**GROWTH MANAGEMENT DEPARTMENT STAFF REPORT**  
**PALM VALLEY OVERLAY DISTRICT**  
**February 22, 2023 Public Meeting**  
**ARCCC 2022-04 Downtown Palm Valley**

**Summary of Request:** Applicant is requesting design approval for a new mixed-use commercial development located at the NW corner of N. Roscoe Blvd and Canal Blvd, along the Intracoastal waterway.

**LS-101**

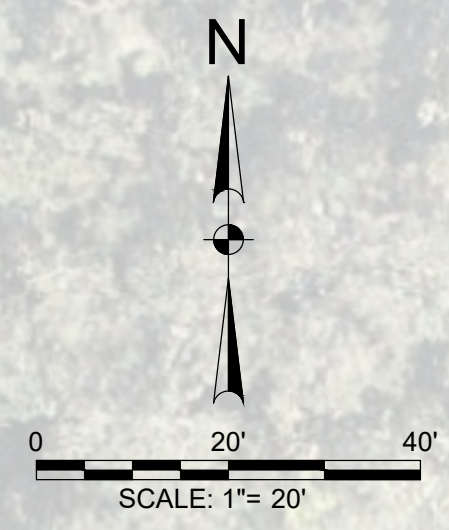
The proposed perimeter buffering appears to be in compliance with LDC Section 3.06.07 for fences and walls. The applicant originally proposed an 8' wall for the incompatibility buffer along the northern property line, but this has since been revised to just provide landscaping and fencing which provides one-hundred percent (100%) opacity to an eight (8) foot height. This would meet the requirements of LDC Section 3.06.06.A.4.

**CSP-01**

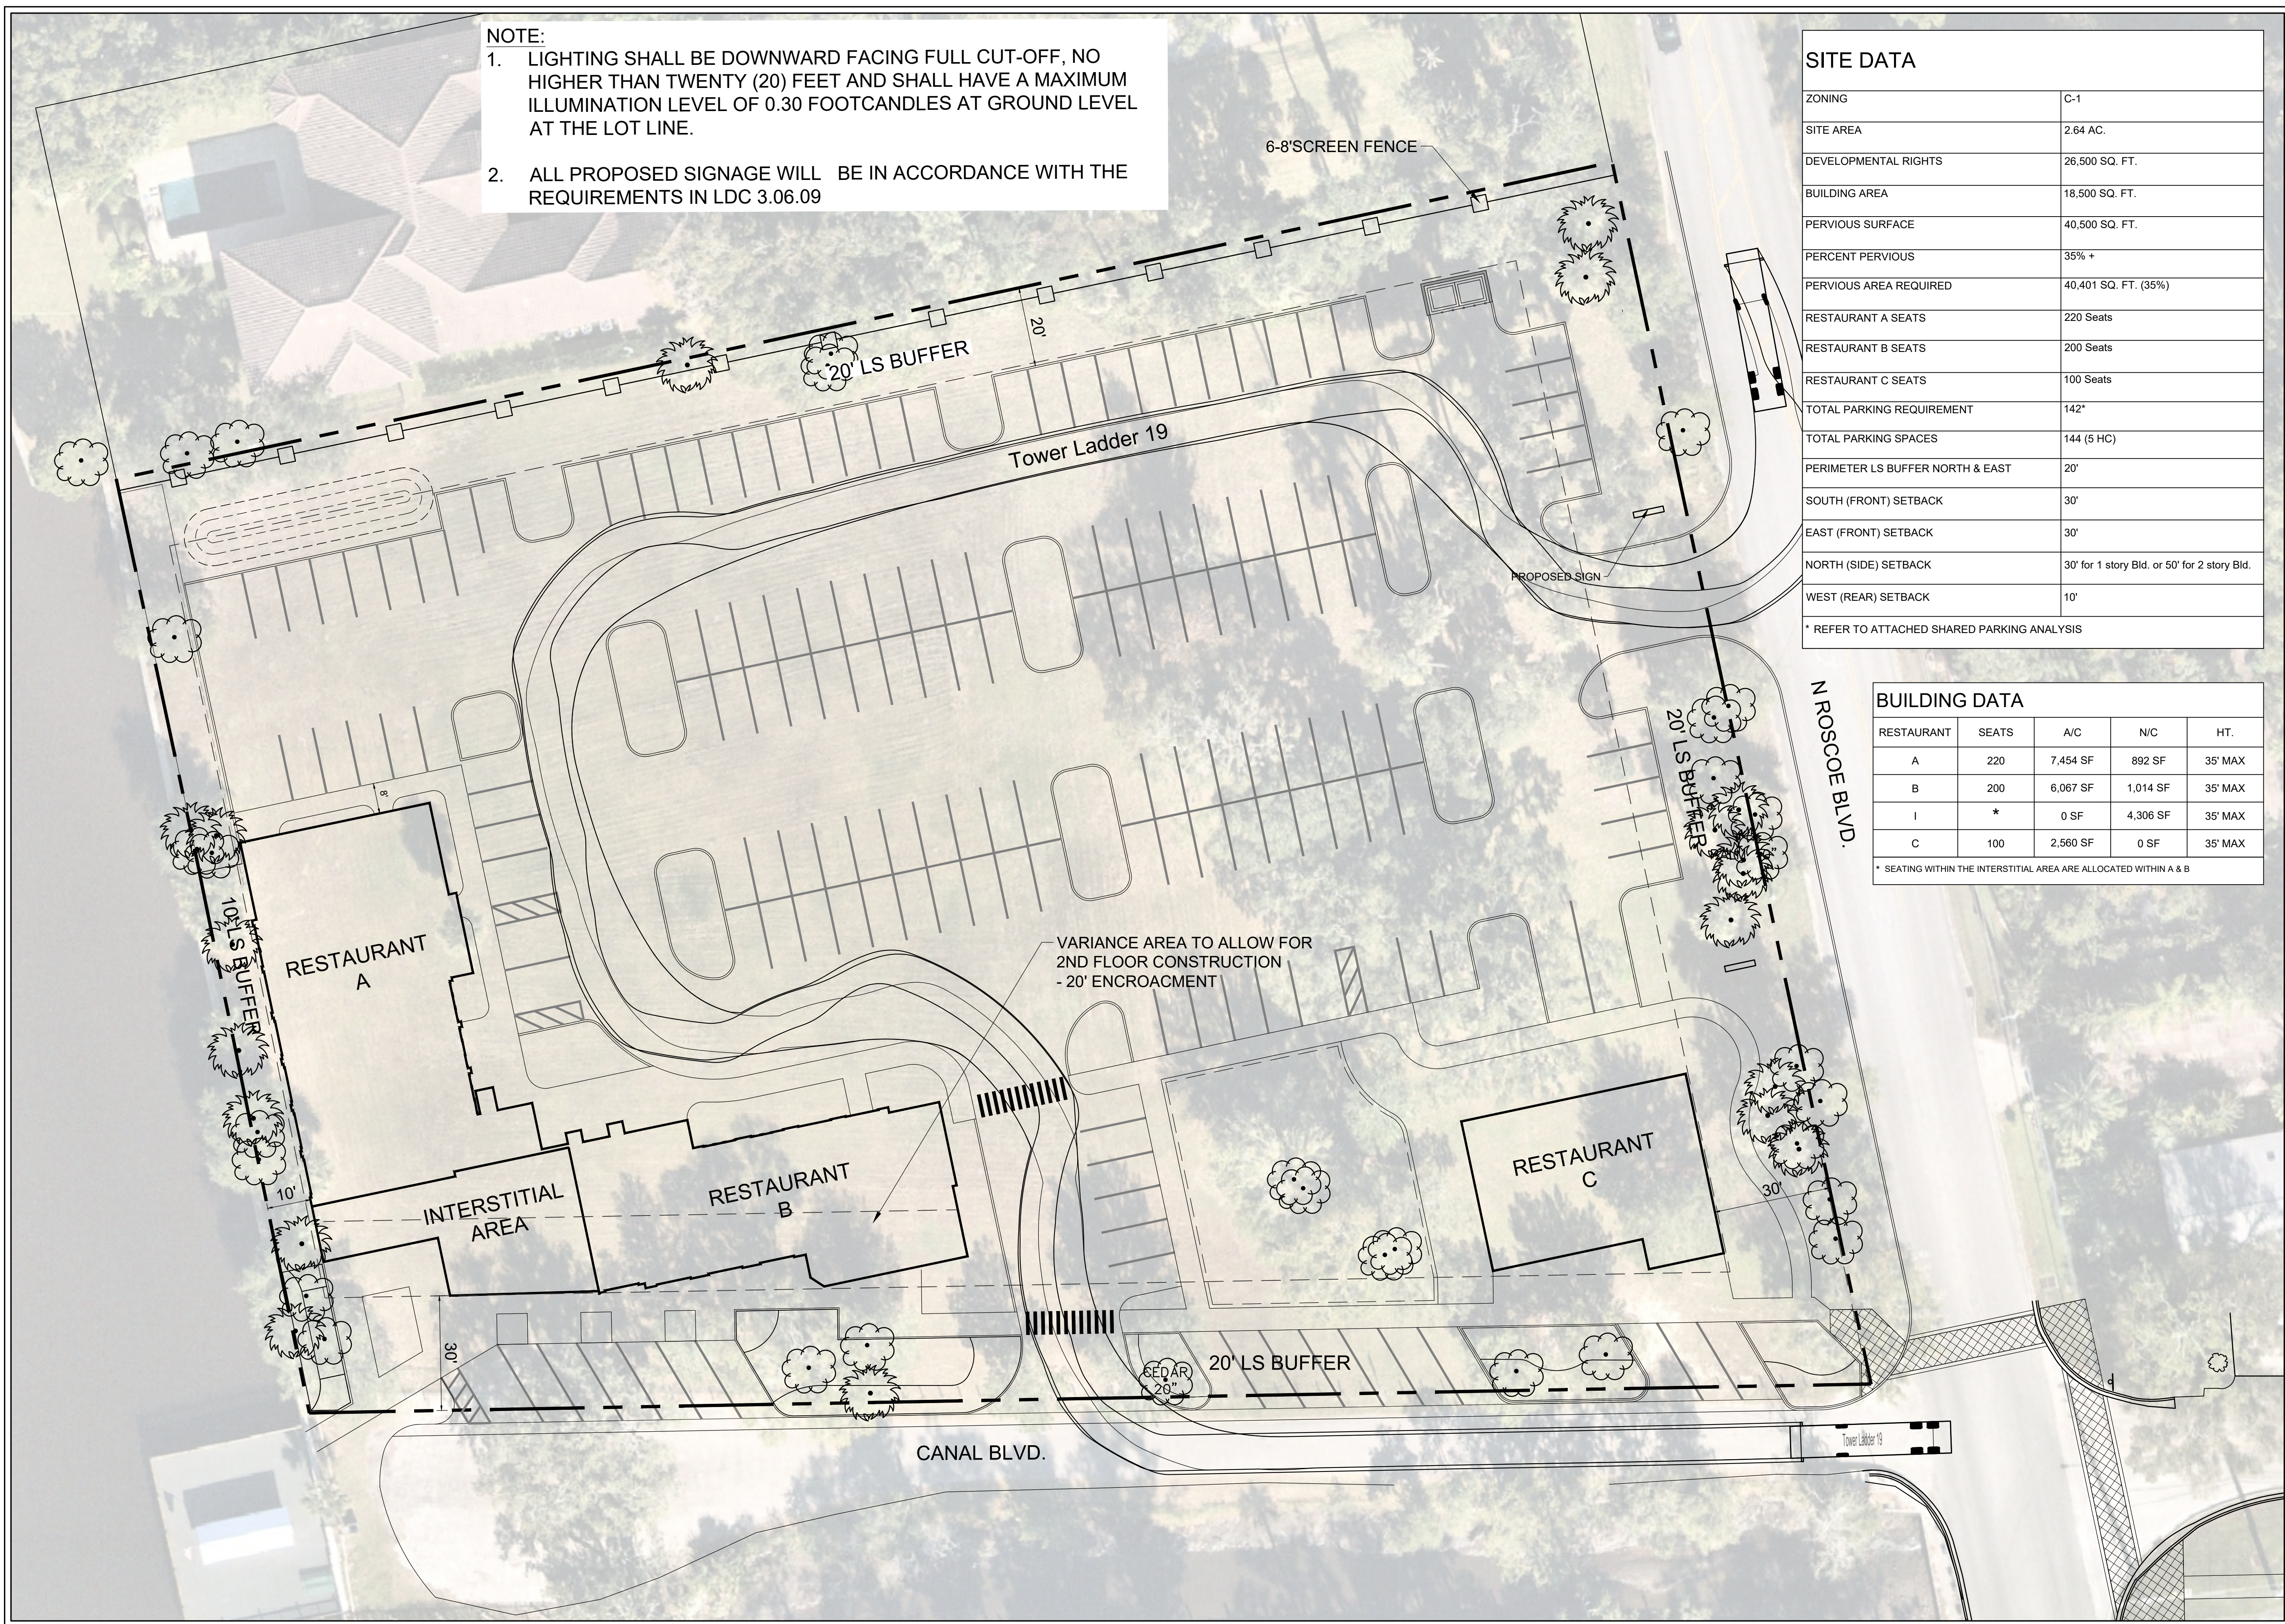
The Lighting Criteria set forth in LDC Section 3.06.13 states that the maximum allowed height for lighting is 20', with a maximum illumination level of 0.30 footcandles at ground level at the lot line. The applicant confirms that the proposed site lighting for the parking lot is consistent with these requirements and will meet them. A Photometric Plan will be required to be submitted with a Commercial Constructoin Plans submittal to confirm compliance.

The applicant confirms on the site plan that signage will adhere to the requirements outlined in LDC 3.06.09.

BUILDING ELEVATIONS

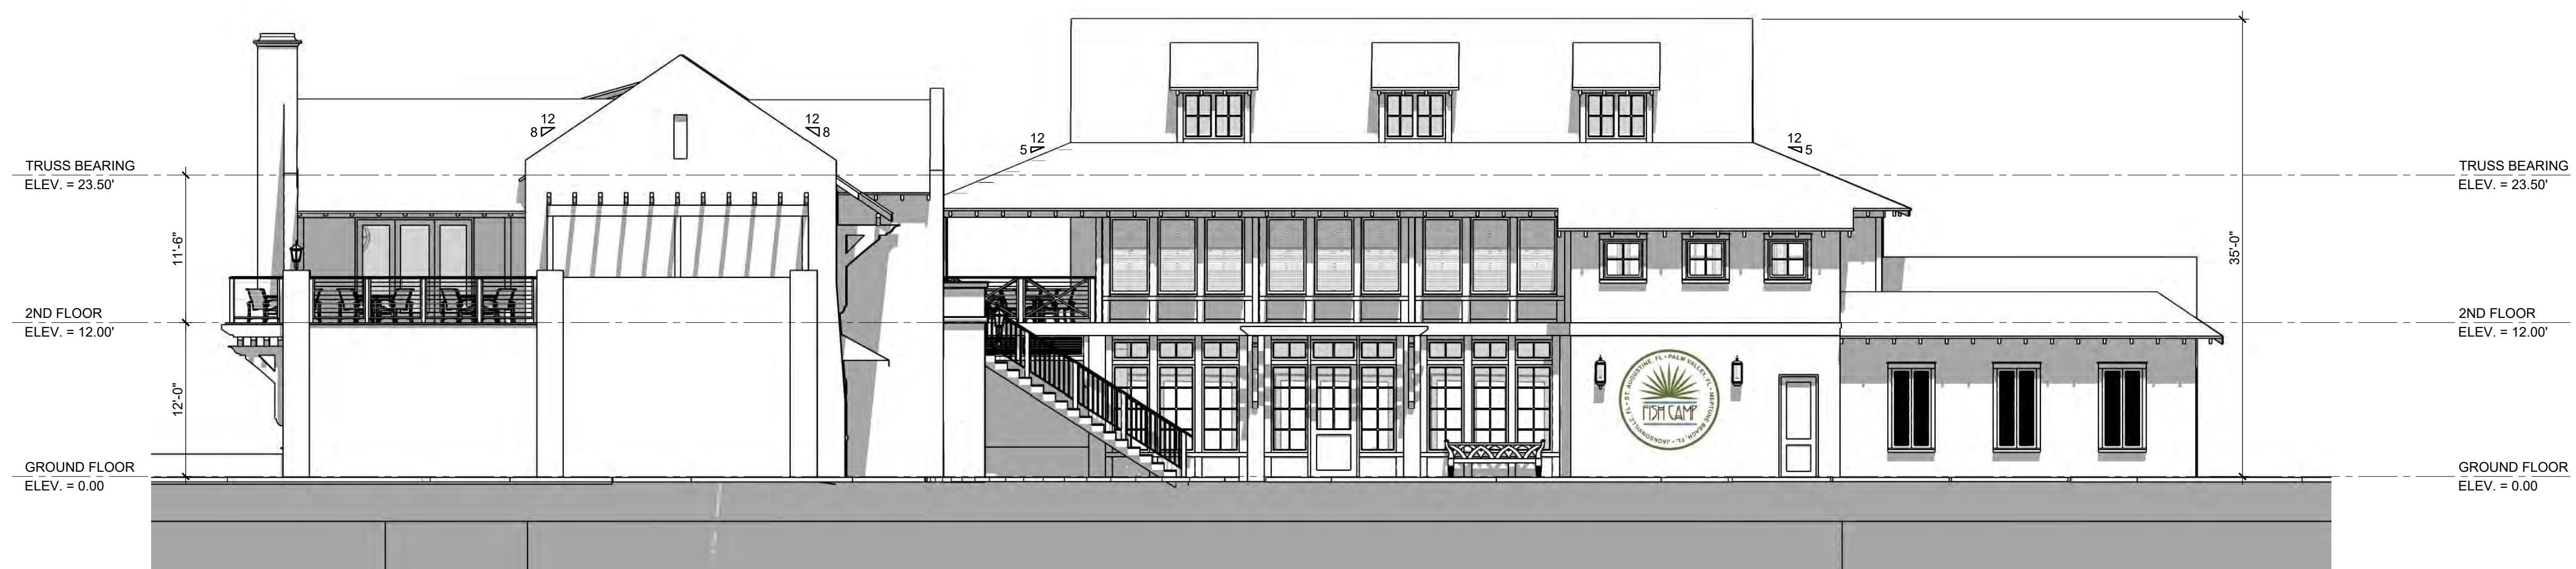
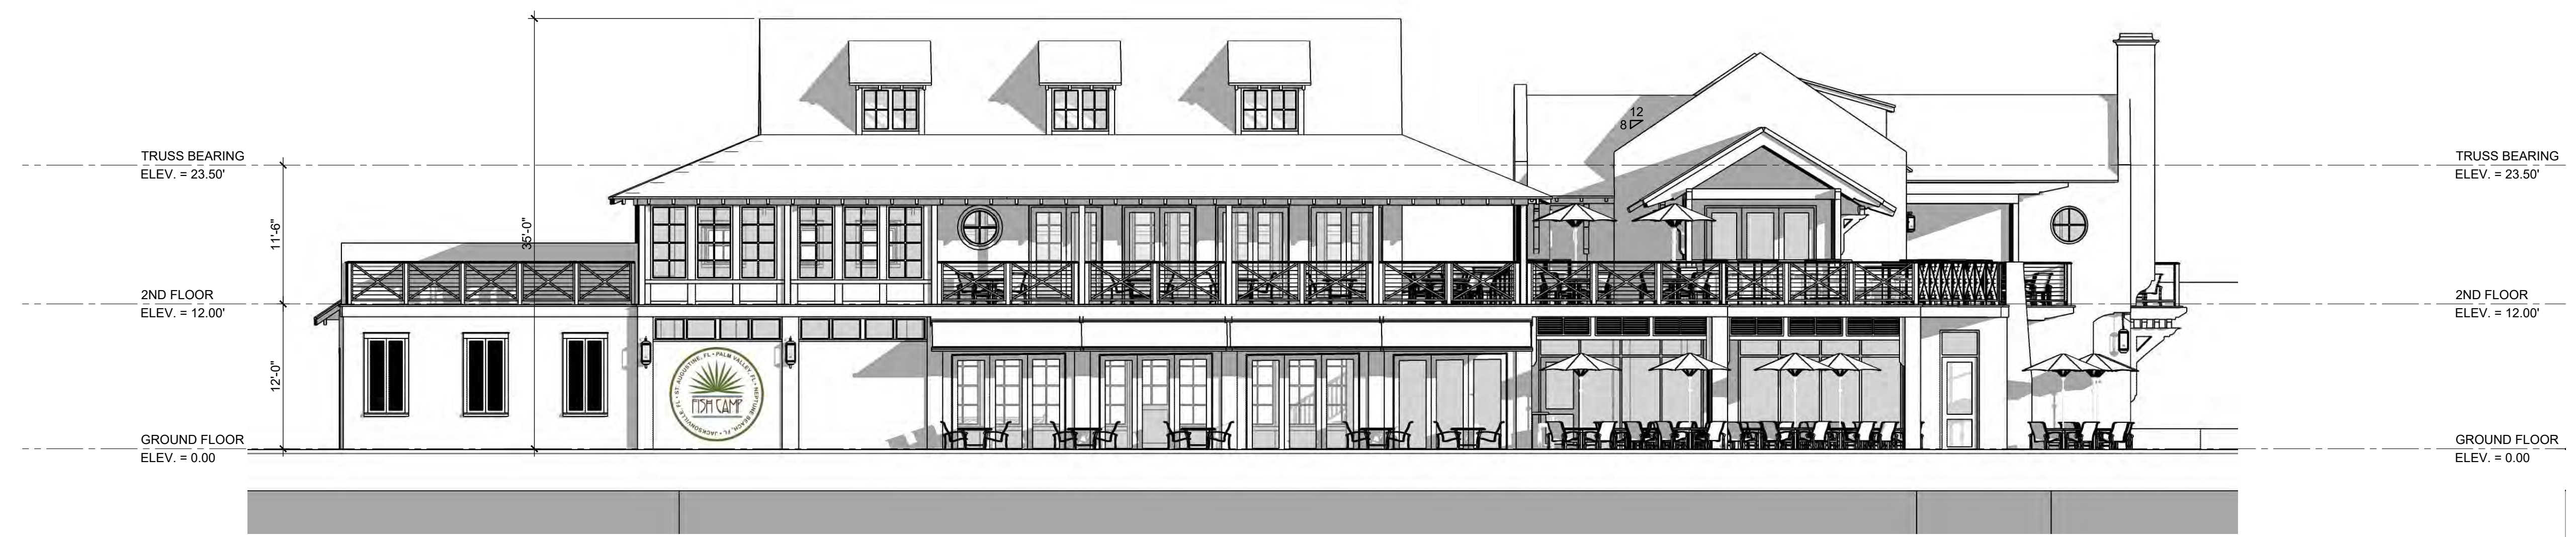
**Planning Division:** The proposed colors and materials of the proposed development appear to be consistent with LDC Section 3.06.11 Architectural Design Standards, and 3.06.12 Design Elements and Materials. The proposed design and colors appear subdued and in harmony with the overall expectations of the Palm Valley Overlay District.
